# SOMERSET MASTER PLAN

Address: 2124 SW Wheatfield Drive, Lee's Summit, MO.  
Lot 151 Hook Farms, 2nd plat

### Change/Revision Log:

2025/08/11:

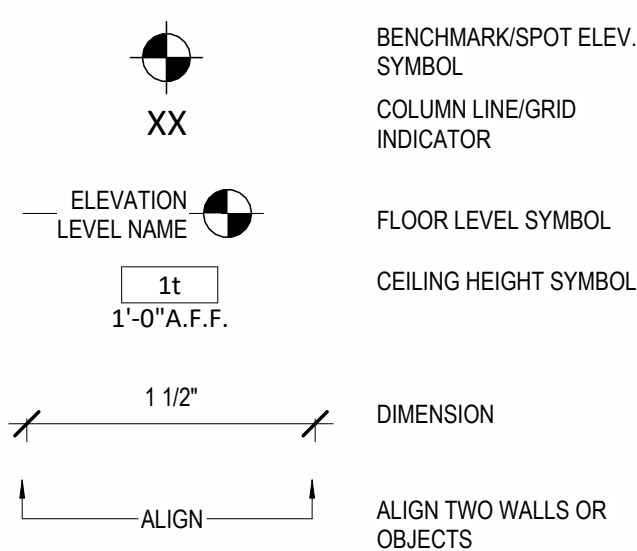
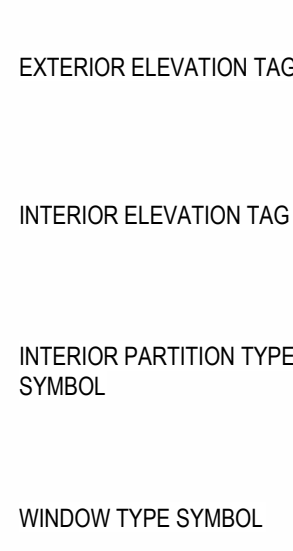
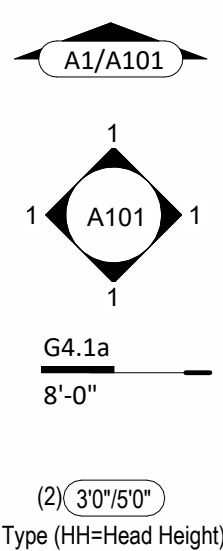
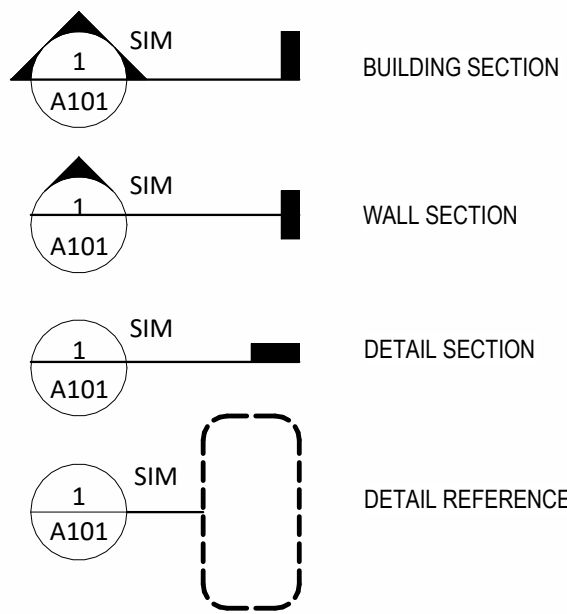
- Removed the closet by front door, and moved it to office/Bed 3 closet.
- Added a cased opening to the hallway going to bed 2 from Foyer.
- Moved the fireplace from back wall to side wall on patio.
- Added header and upright to support the ridge beam after removing FP.
- Made the egress window in Bed 2 a single hung from casement.
- Made the Walk-in-closet 9' high from 10' high.
- Replaced 2/4 pantry door with a 2/8 cased opening.
- Detailed interior elevations on page A702.
- Moved the top plate of the main roof over by a foot towards front to avoid clipping rafters over front door.
